CITY OF ALBUQUERQUE

RE: Santa Monica Place (Senior Assisted Living/Memory Care)
East End of Tract 3
Grading and Drainage Plan
Engineer's Stamp Date 10-16-2015 (File: D18D054B)

Based upon the information provided in your submittal received 10-23-2015, the above-referenced plan is approved for SO-19 Permit. The Grading Permit and Building Permit are approved with the following conditions:

CG-101

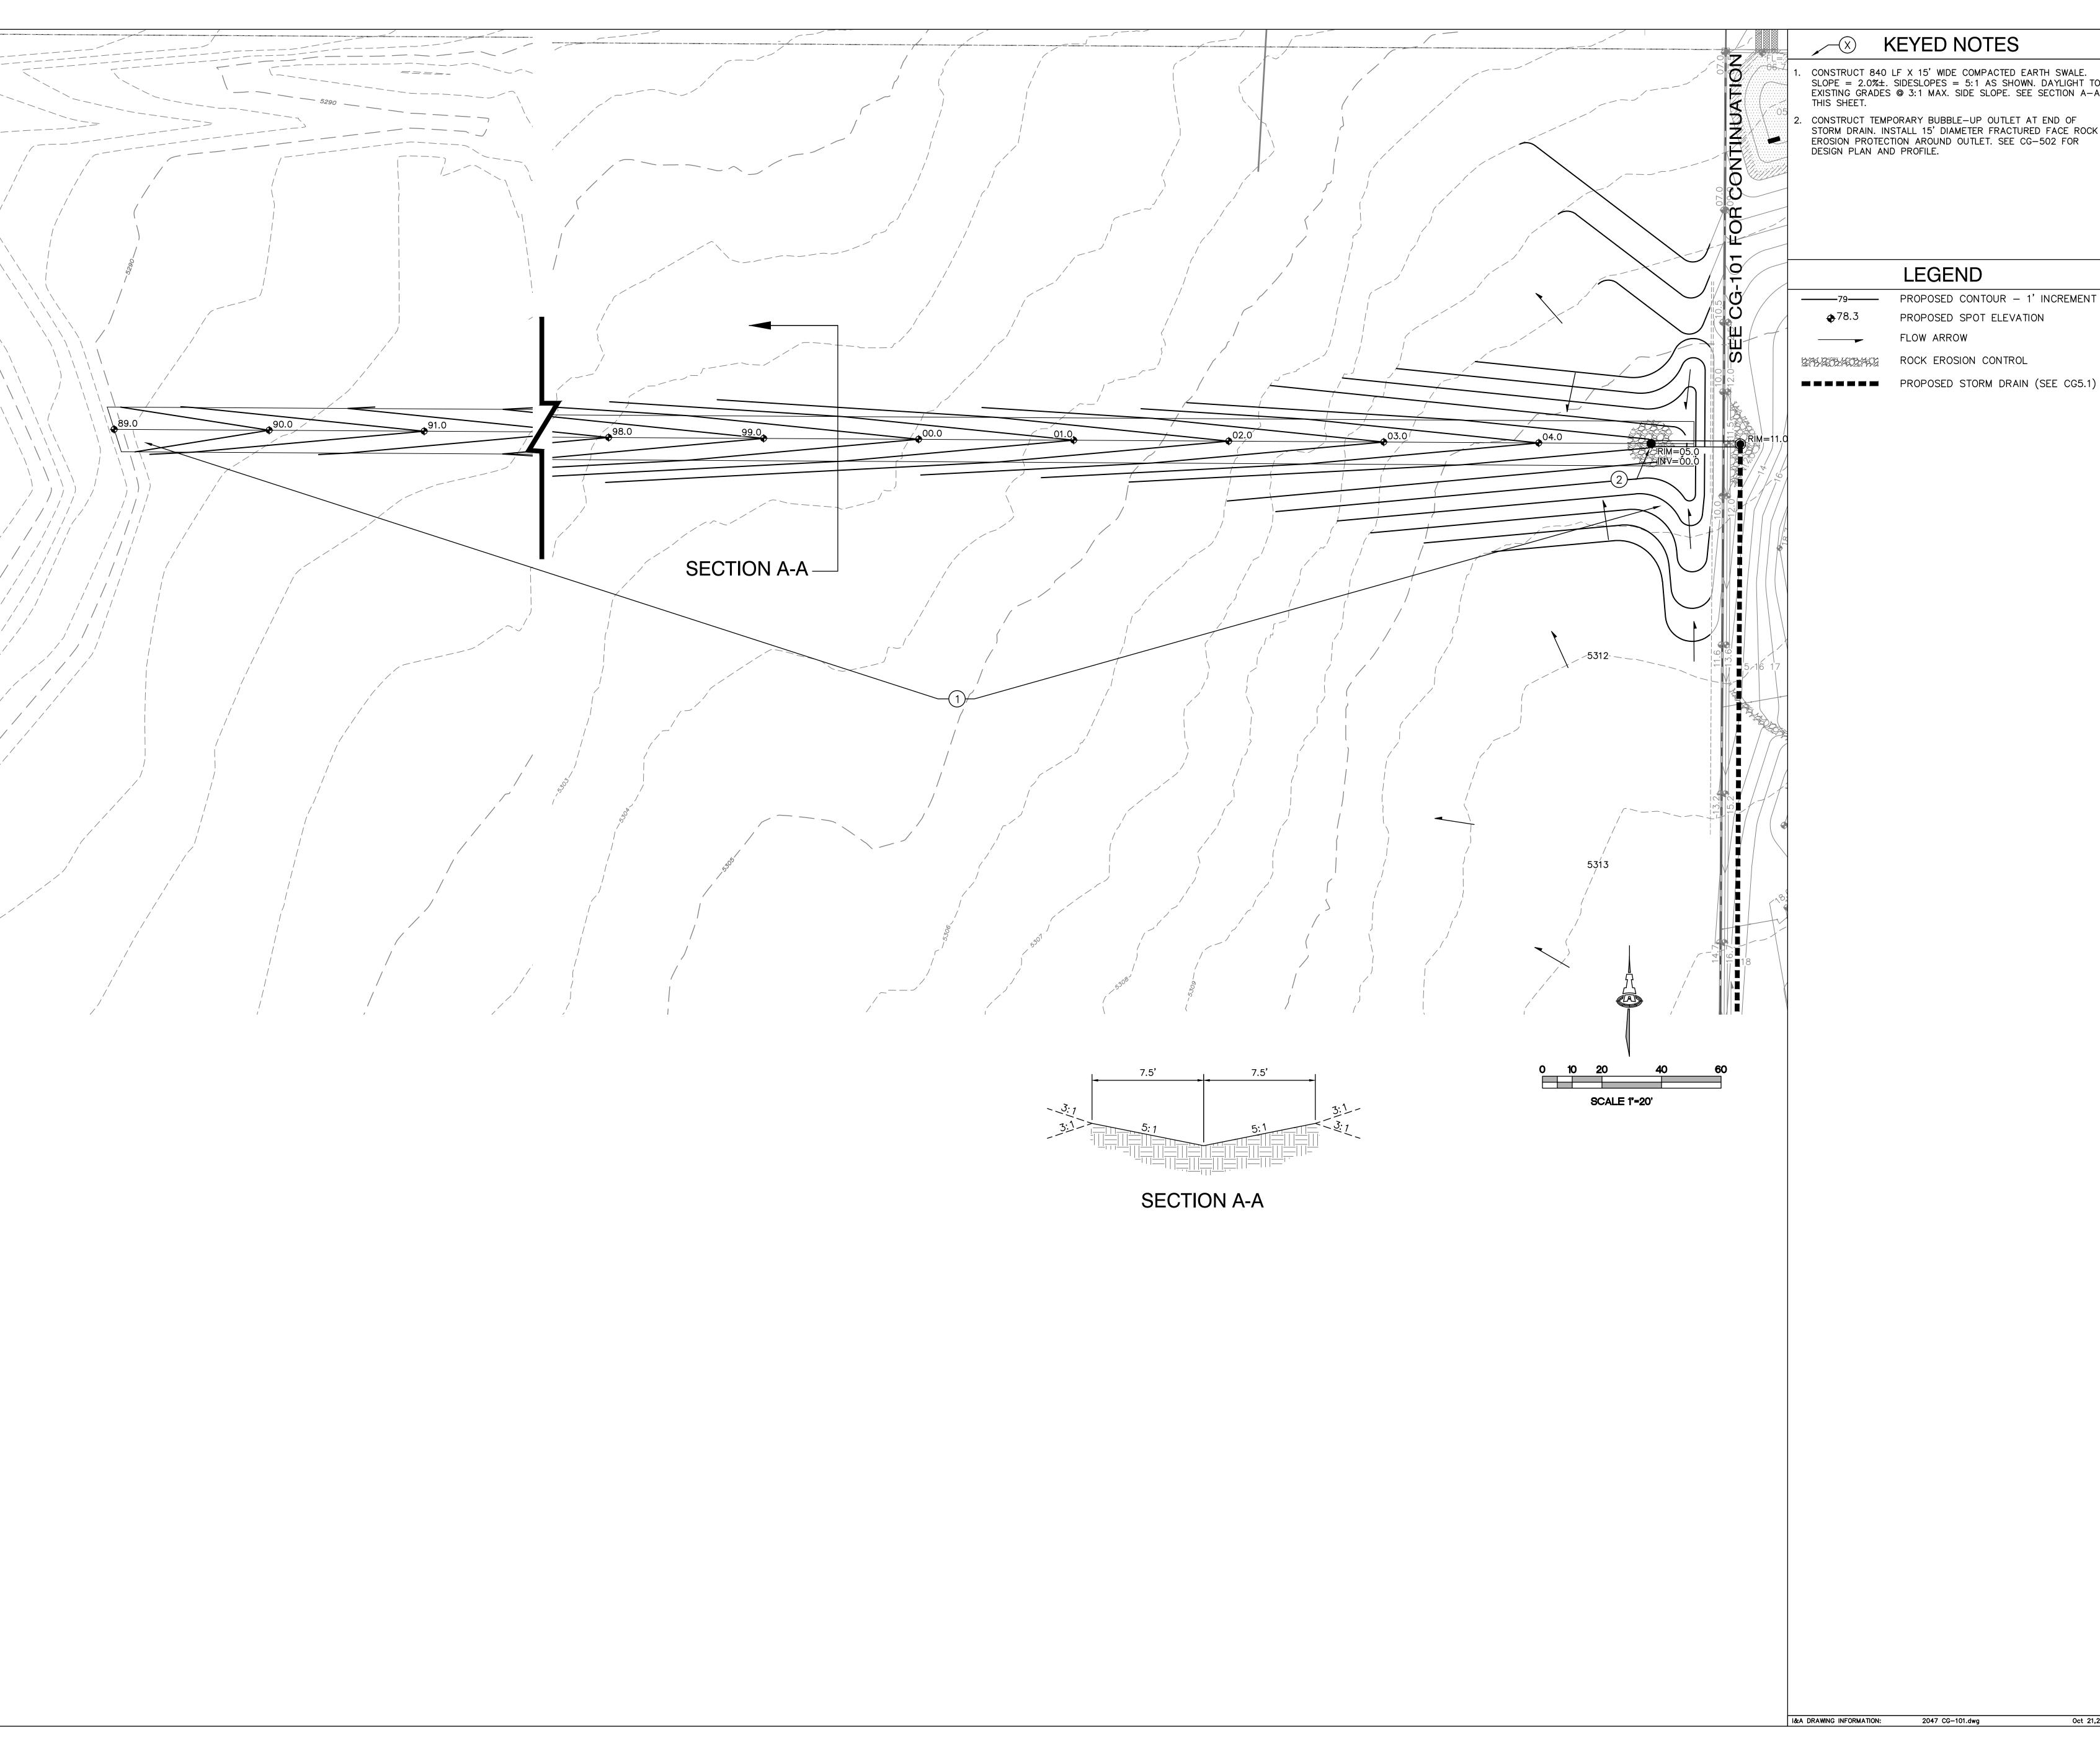
- Specify class IV RCP for the 24" storm drain that will be placed under the retaining wall (or other class only if justified).
- Albuquerque
- It is assumed that the hatched rectangles shown within the ponds are the percolation pits referenced in Keyed Note 7 on Sheet CG-101.
